# RENESAS TECHNICAL UPDATE

Product Category	MPU&MCU		Document No.	TN-SH7-A684A/E	Rev	1.00
Title	Note on Use of SH7780 SIOF Master Mode 2		Information Category	Technical Notification		
Applicable Product	SH7780 Group	Lot No.	Reference Document	SH7780 Hardware Manual Rev.1.00 Dec.13.2005 (REJ09B0158-0100)		
		All lots

Figure 1. SIOF\_SYNC Output Timing in Master Mode 2 (Transfer Started)

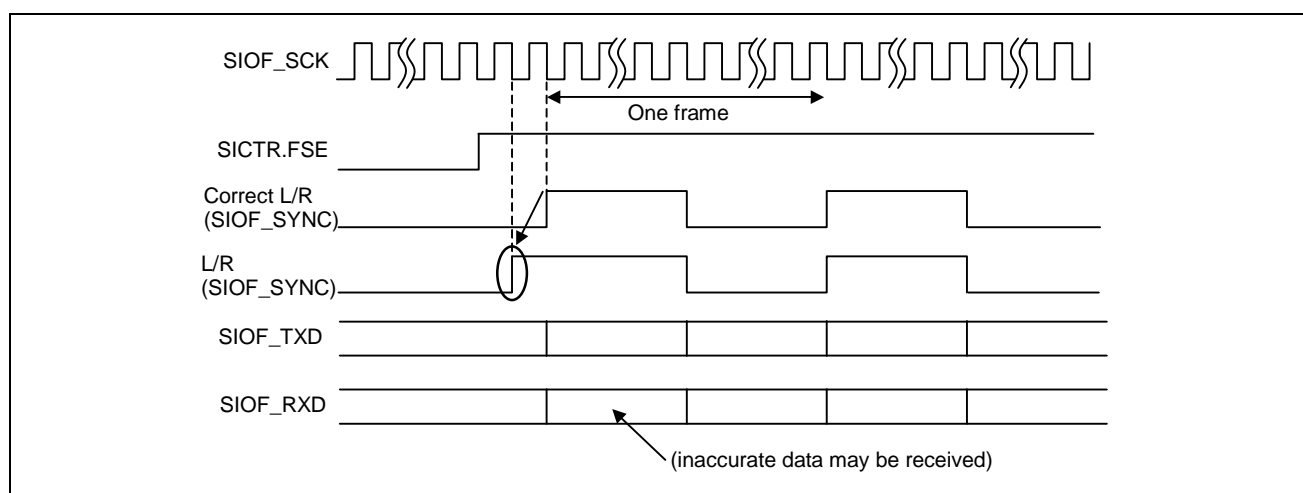
When using master mode 2 of the SIOF, if a transfer is started as set SICTR.FSE to 1 after reset, the first L/R signal (SIOF\_SYNC) is always asserted early for one clock (see figure 1). And if a transfer is suspended as clear SICTR.FSE to 0 and resumes as set SICTR.FSE to 1 again, the first L/R signal may be asserted one clock late (see figure 2). In any case, an inaccurate data may be received at the first slot of received frame.

1. When the L/R signal asserted early for one clock.

There is no suitable workaround about the SIOF of the SH7780. If this operation is the problem in your system, take the countermeasure on your system for example ignore the first data.

If any countermeasure cannot be used on your system, use the SSI instead of the SIOF. However, the SSI cannot perform the full-duplex transfer by multiple slots. Furthermore, the SIOF cannot be used when use the SSI because of the SH7780 pin configuration.
